Final Supplemental Environmental Impact Report

Trumark Dumbarton Transit Oriented Development Residential Project

March 2014

A. RESPONSE TO COMMENTS FROM SAN FRANCISCO BAY REGIONAL WATER QUALITY CONTROL BOARD (RWQCB), FEBRUARY 7, 2014.

FIGURE 3-4

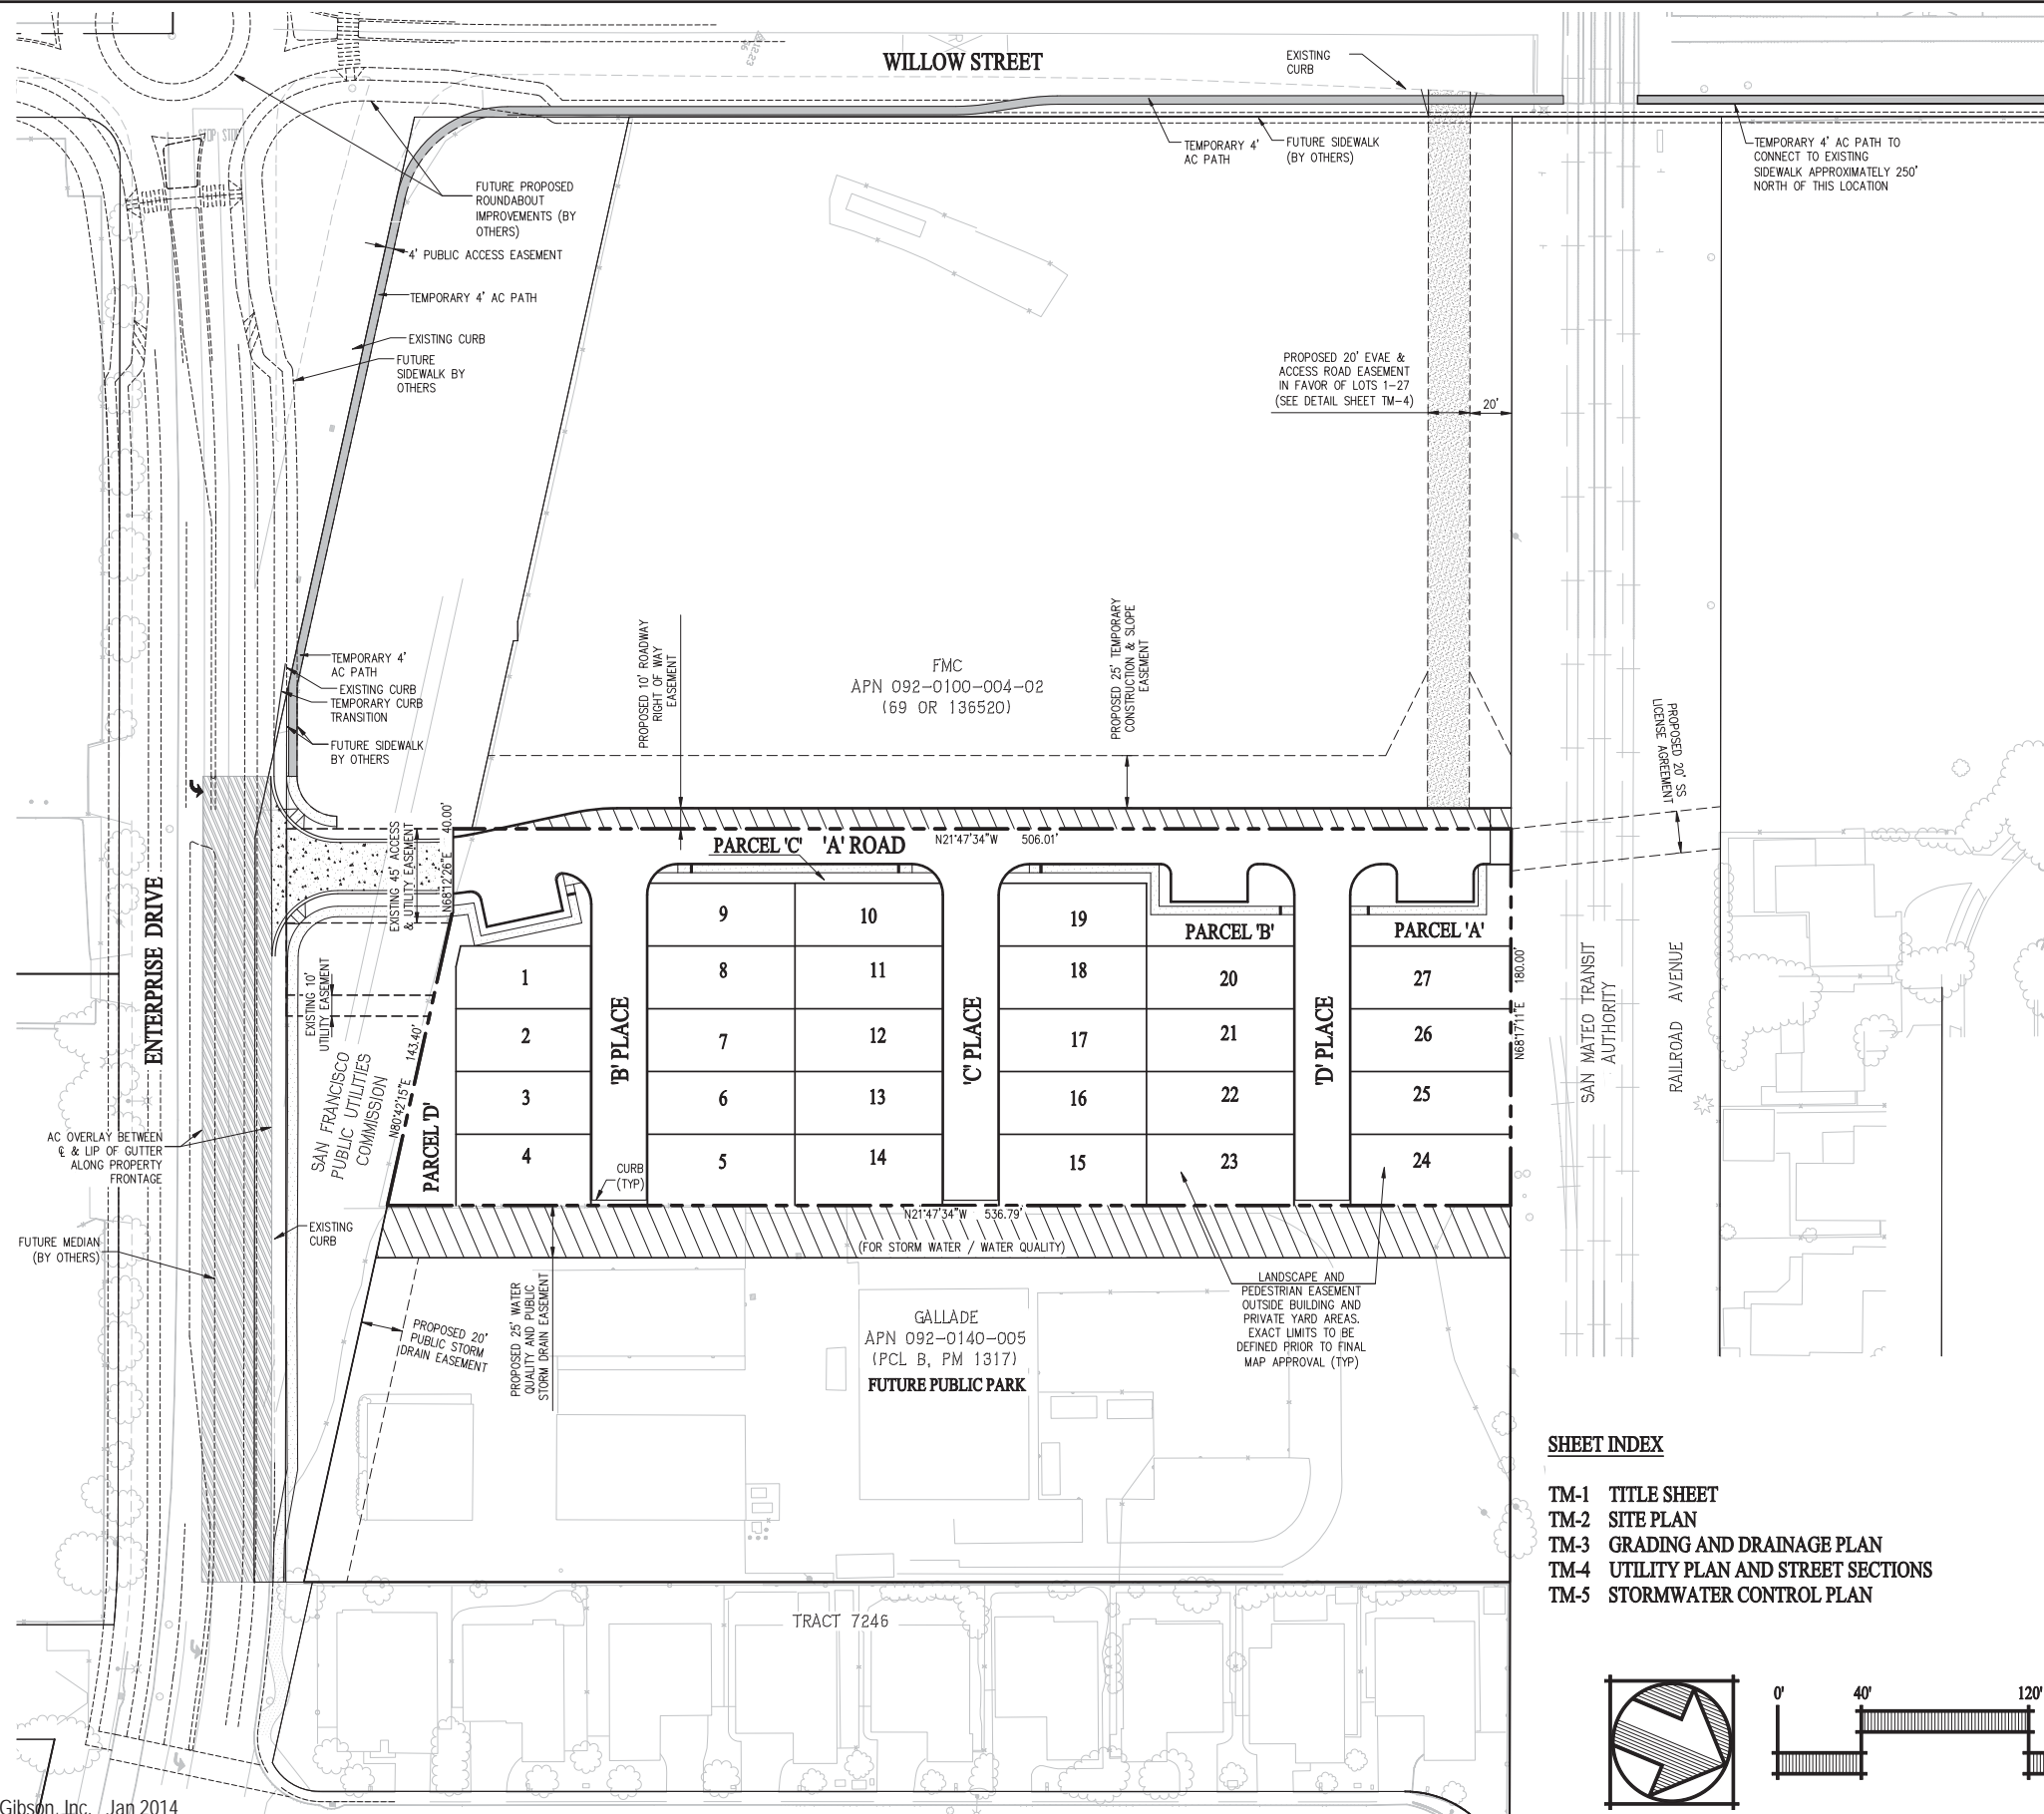
Given the location and proposed development of Site "A" shown on the Figure 3-4 of the Draft SEIR, the District will require the project to install both a water main extension crossing of the SFPUC right-of-way and a water main connection extending from the project into Willow Street to connect to the existing 16-inch water main within Willow Street on the North side of the railroad right-of-way. In lieu of the requirement for both water mains to be installed for system looping, the District may consider requiring only one connection across either SFPUC or railroad right-of-way if the project proponents can secure a perpetual, irrevocable easement dedicated to ACWD for the water system across either right-of-way.

RESPONSE D-2: The commenter states that an EVA access is not shown in the SEIR. Figure 3-4 has been revised to show such access. The commenter requests a project review meeting. This comment does not state a specific concern about the adequacy of the Draft SEIR or otherwise comment on the contents of the Draft SEIR. Therefore, a response is not required. However, this comment has been noted for the record and will be provided to the Planning Commission and City Council for consideration. The City anticipates that the developer will have further meetings with the SFPUC to address any outstanding issues. Refer to **Section 5.0 Revisions to the Figures of the Draft SEIR.**

RESPONSE D-3: The commenter states that it will not issue a land engineering permit unless an EVA access is provided. As noted in Response D-2, an EVA that will not be available to the general public will be provided over the adjacent FMC Parcel (to the west) and Figure 3-4 has been revised to show such access. This comment does not state a specific concern about the adequacy of the Draft SEIR or otherwise comment on the contents of the Draft SEIR. Therefore, a response is not required. However, this comment has been noted for the record and will be provided to the Planning Commission and City Council for consideration. The City notes that the commenter's July 2, 2013 project review minutes confirm that the developer will obtain approval from commenter to conduct testing to determine SFPUC's location and depth and that the developer will submit plans to the SFPUC for review. The minutes also indicate that the developer will need to obtain authorization to maintain landscaping and sidewalks on the commenter's right of way. The City anticipates that the developer will have further meetings with the commenter to address any outstanding issues as requested by commenter. Refer to **Section 5.0 Revisions to the Figures of the Draft SEIR.**

completed prior to the City's approval of the specific EVA alignment, and what is depicted in Figure 3-4 is conceptual, and as noted above, subject to change. See Figure 3-4, as revised.

This section contains a revised Figure 3-4 to the *Draft Supplemental Environmental Impact Report, Trumark Dumbarton Transit Oriented Development Residential Project*, dated December 2013.
